**Project #20-012  
Cardall Metal Buildings  
Located at 1340 W 250 N**

*Project Name:* Cardall Metal Buildings  
*Proponent / Owner:* Courtney Wallace (Cartwright AEC, Inc)/Valley View Business Complex LLC  
*Project Address:* 1340 W 250 N  
*Request:* Design Review Permit  
*Current Zoning:* Commercial (COM)  
*Type of Action:* Quasi-Judicial  
*Hearing Date:* February 27, 2020  
*Submitted By:* Aaron Smith, Planner II

Staff recommends that the Planning Commission **conditionally approve** a Design Review Permit for Project #20-012, Cardall Metal Buildings, for a 12,800 SF and a 6,720 SF industrial building at 1340 W 250 N, TIN #05-100-0004;-0005;-0006;-0007.

**A3 EAST FACING EXTERIOR ELEVATION**  
SCALE: 1/8" = 1'-0"

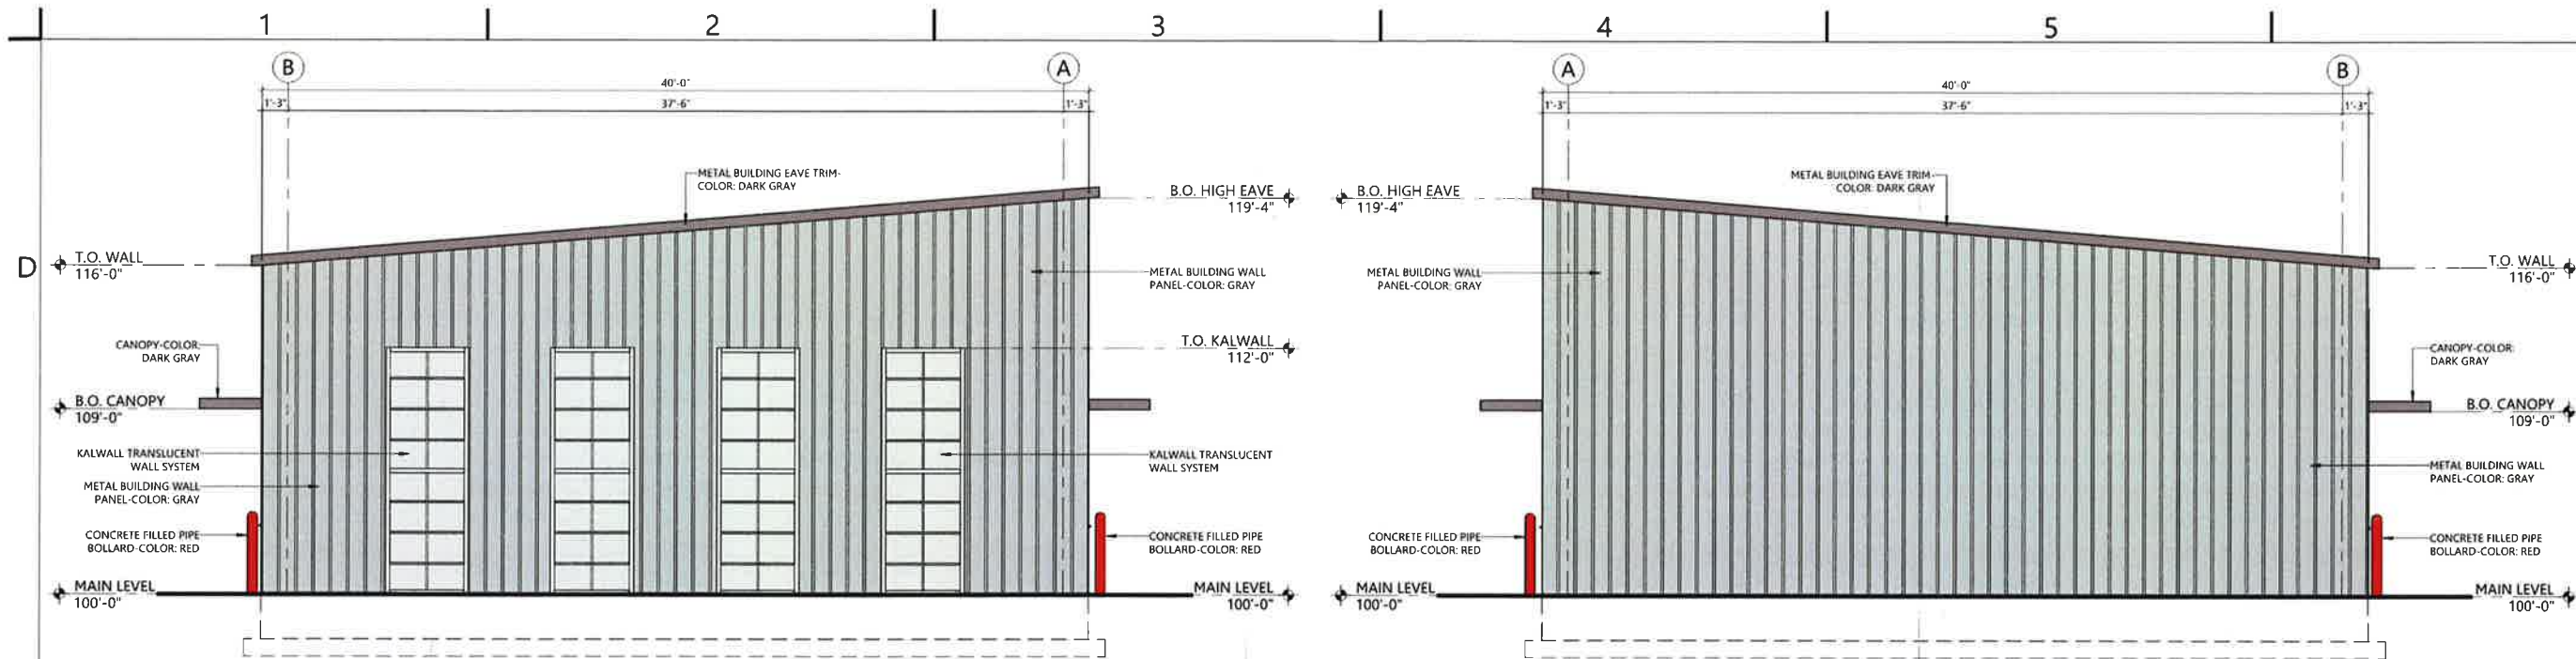
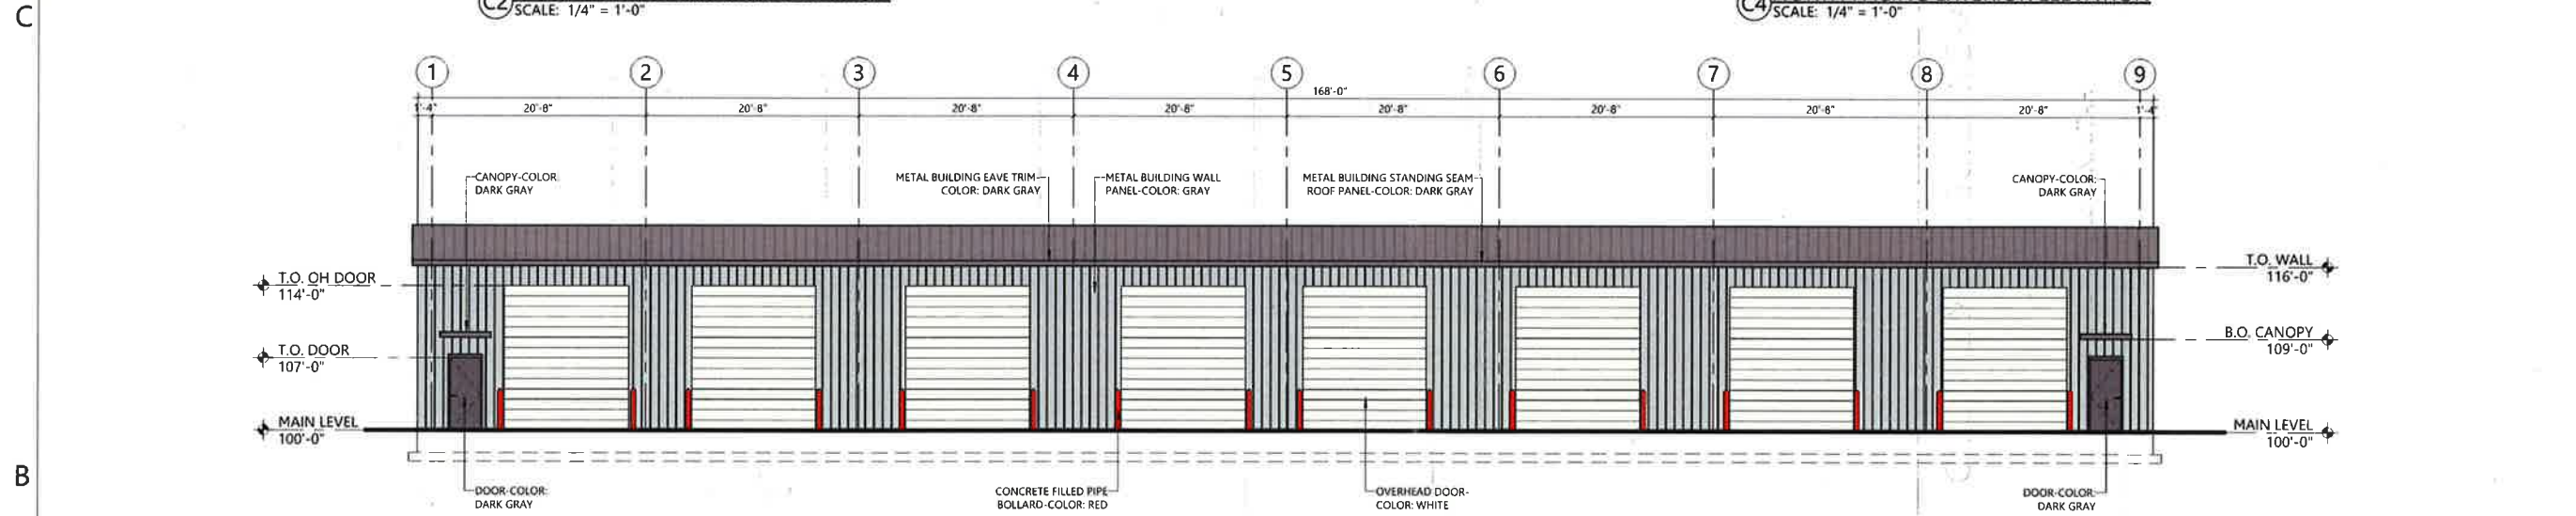
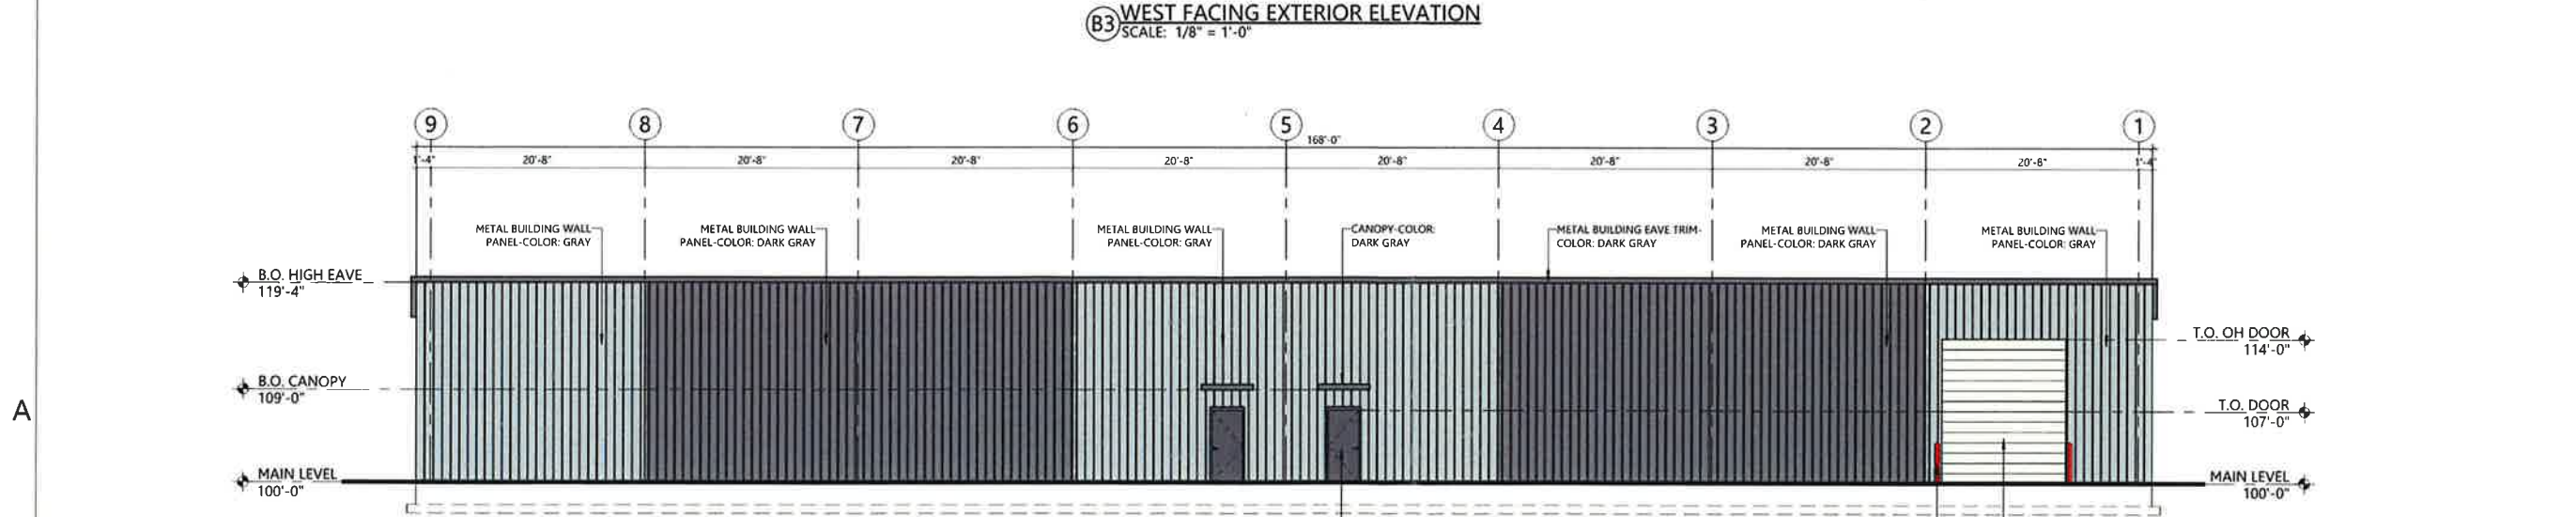
The CS standards require minimal building form features to break-up building mass and scale. The LDC states that blank walls greater than 40' are not permitted along facades visible from a public street, and that two methods must be used to create interest and reduce scale. Methods mentioned in the code include staggering of vertical walls, recessing openings, providing upper-level roof overhangs, using deep score lines at construction joints, contrasting compatible building materials, and using horizontal bands of compatible colors. The east elevation provides contrasting colors, but a second method along the façade for both the south and north buildings is required. Staff recommends that vertical landscaping be utilized along these facades to break up the form, as a plant strip is required along these facades. As conditioned, with a second method for breaking up building mass along the east facades of the proposed buildings, the project complies with the requirements of the LDC.

9. The east elevations of new buildings shall include at least two methods to break-up monotonous building design.
10. Building entrances along the west elevation of the southern building that are visible from the public street shall have a minimum off-set of 4'.
